To: John Tunstall
From: Pat O’Mahony, Associate Planner; 910-341-0189
CC: File;
Date: 4/21/2020
Re: NHRMC Health Dept. Parking Lot Formal TRC Rev. 1

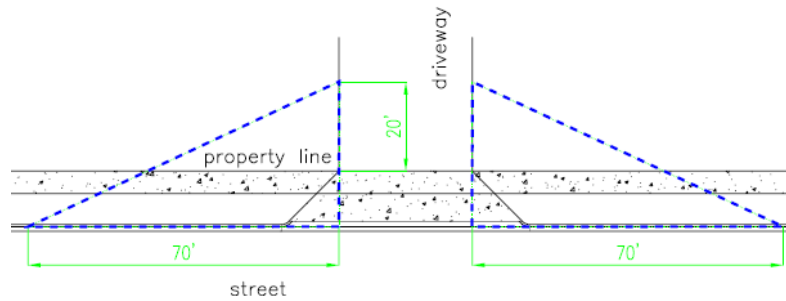
- Map of recombination required prior to approval.
- Details required for parking calculations to justify additional parking spaces.
- Landscape Plan to Include:
 - A landscape island is required at the end of the parking row shown below:
